QUALIFICATION OF PURGE AND VENT VALVES AT WNP-2

ATTACHMENT K - FIELD MODIFICATIONS, PED & STARTUP WORK REQUESTS

REASON FOR P. E. D. :
TO IMPLEMENT COMMITMENTS TO
NRC THE STRUCTURAL MODIFICATIONS
DESCRIBED BELOW SHALL BE MADE
TO VALVES CSP-V-1, 2, 3, 4, 5, 6 AND
CSP-V-9 ALSO CEP-V-1A, 2A, 3A AND
CEP-V-4A:

SUBJECT	STRUCT. MODIFICATION TO FORCE MAIN	VALU
LOCATION	R. B	
ENG. SYSTEM	CSP & CEP.	
SU SYSTEM	23.0	
QUALITY CLASS	I

REF DOC PCN	RFI	WPPSS NUCLEAR PROJECT NO. 2	
REF SPEC SECTION	PAGE	BURNS AND ROE, INC.	
REF DWG	DWG ZONE	PED 215-B-X087	SHT 3 OF 10.
SCALE	DRAWN BY	TITLE. SHEAR PLATE	
	DATE	ADDITION	
BY	DATE	APPVD	DATE

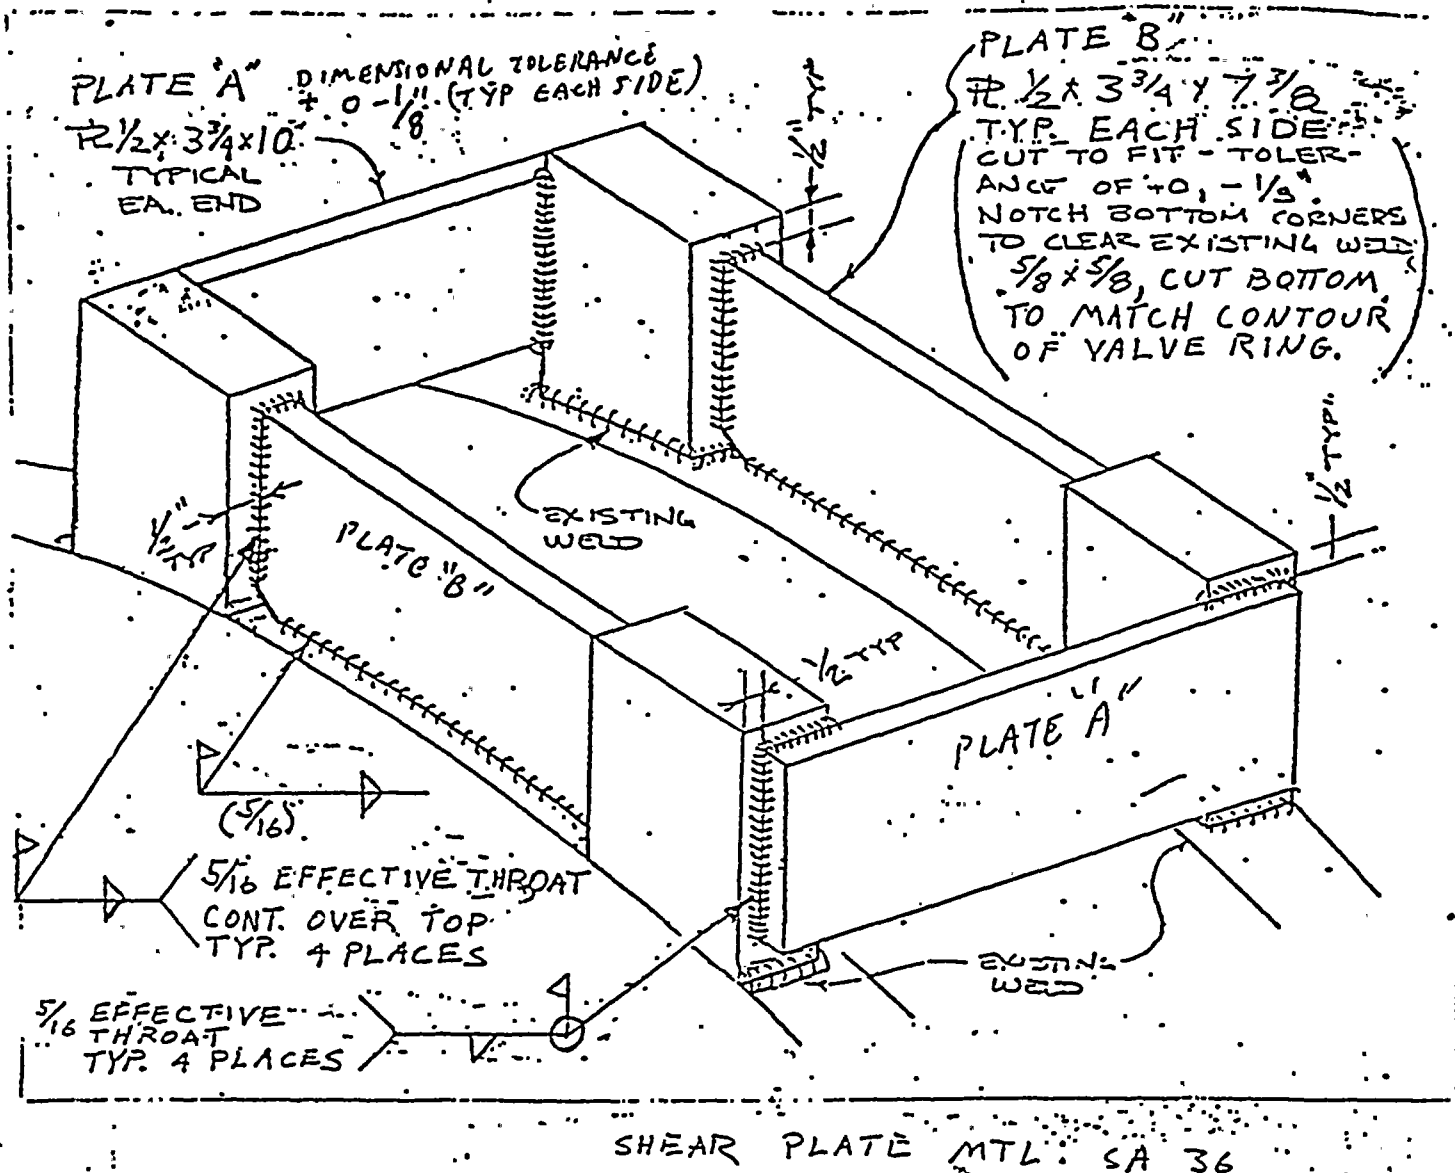
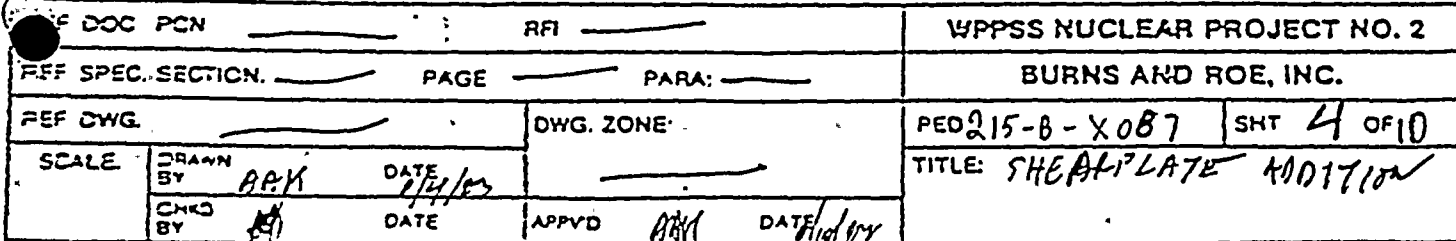
DESCRIPTION OF WORK: 1) THE CONTRACTOR SHALL REPLACE THE FOUR (4) EXISTING ASTM A307 STUD BOLTS USED TO SECURE THE OPERATOR ASSEMBLY ON TO THE VALVE'S OPERATOR ASSEMBLY SUPPORT POSTS, (VALVE EARS) WITH STUD BOLTS CONFORMING TO ASTM A325 OR ~~ASTM A325~~ ² APPROVED EQUAL

2) THE CONTRACTOR ^{SHALL} MODIFY (ADD BRACING) TO THE OPERATOR ASSEMBLY SUPPORT POSTS AS SHOWN ON THE ATTACHED SHEETS.

ATTACH PLATES A" & B" TO THE VALVE POSTS AS SHOWN.
 THIS DETAIL APPLIES TO VALVES CSP-V-1&2 AND
 CEP-V-1A & 2A. ALL WELD METAL E 7018 PREHEAT TO 200°F MIN
 $1/2$ " MAX FILLET. EXEMPTED FROM POST WELD HEAT TREATMENT
 PER ASME III NC 4622.7
 TO BE REPAIRED UNDER ASME SECTION II GUIDELINES

REF. DOC: PCN		RFI		WPPSS NUCLEAR PROJECT NO. 2	
REF SPEC. SECTION:		PAGE:		BURNS AND ROE, INC.	
REF DWG: 68-00-0010		DWG. ZONE:		PED215-B-X087 SHT. 5 OF 10	
SCALE:	DRAWN BY: JCF	DATE: 8/4/80	TITLE: NOTE		
CHKD BY: ARV	DATE: 8/10/80	APPVD: AMM	DATE: 8/10/80	ADDITION

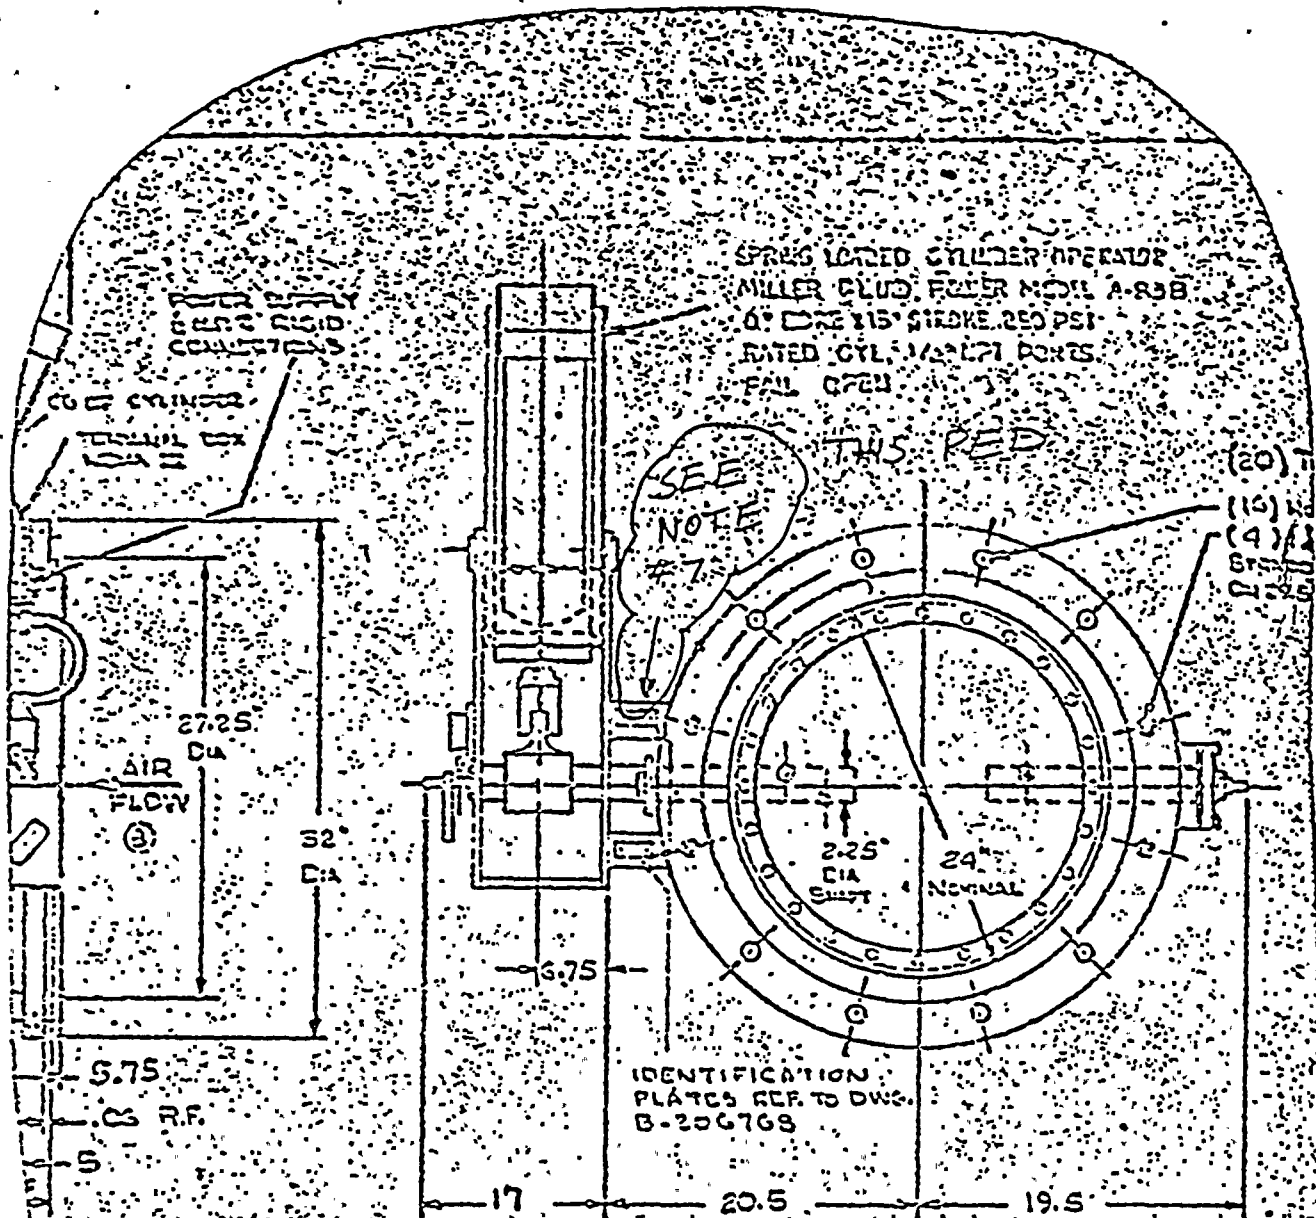
SPRING LOADED CYLINDER OPERATOR
 MILLER CLUD. FILER MODEL A-83B
 6" DIA 15" STROKE 250 PSI
 RATED CYL. 1/2" LPT PORTS
 FAIL OPEN

7. SEE PED 215-B-X087 FOR
 DETAIL OF SHEAR PLATES
 ON OPERATOR SUPPORTS.

System CEP/GSP

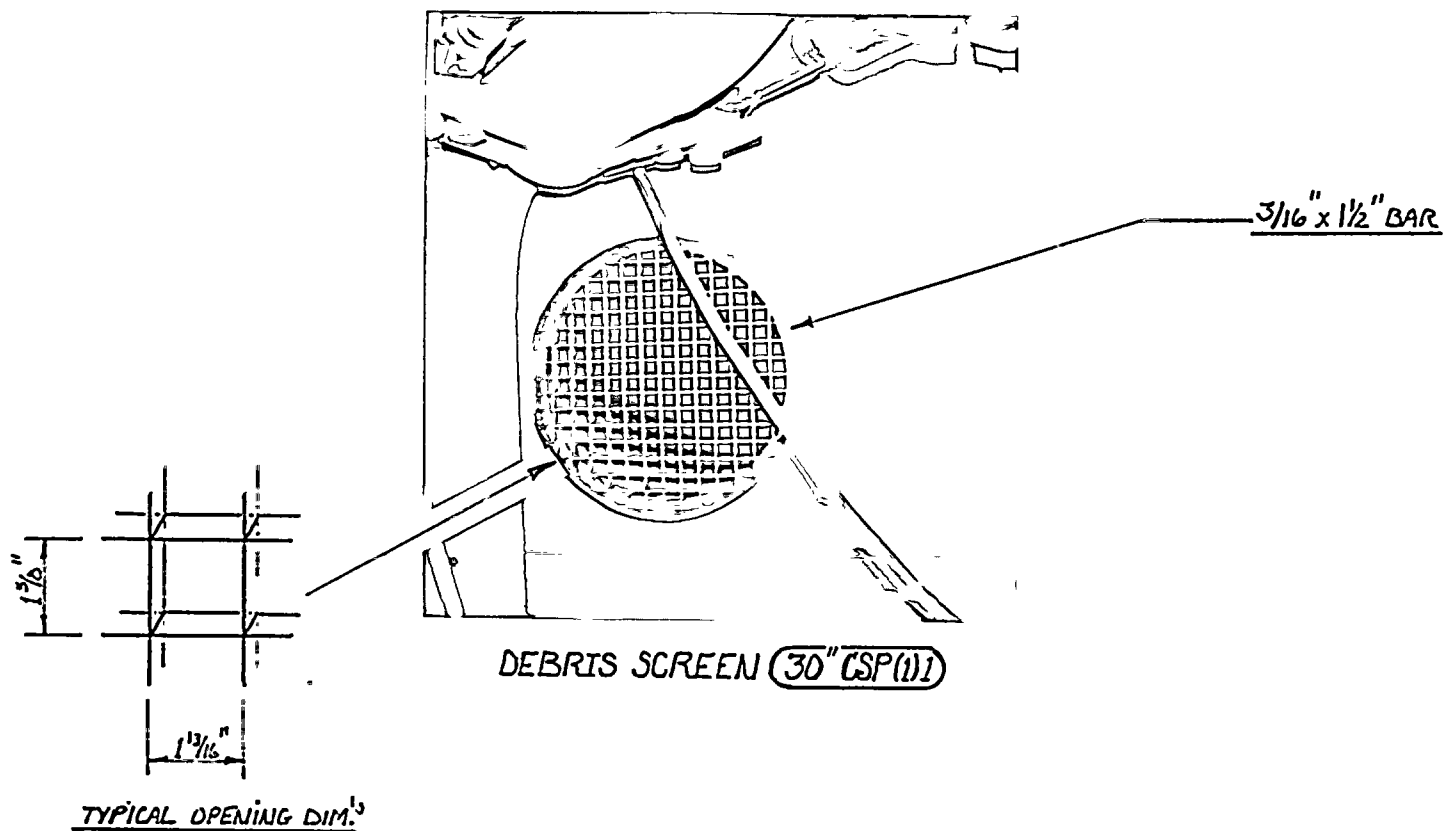
The attached sketches modify design details provided in the referenced letter. The valve analyses have been reviewed and found to be acceptable with this modification. The change was necessary, as the clearance and physical conditions of the valves limited the amount of additional bracing possible.
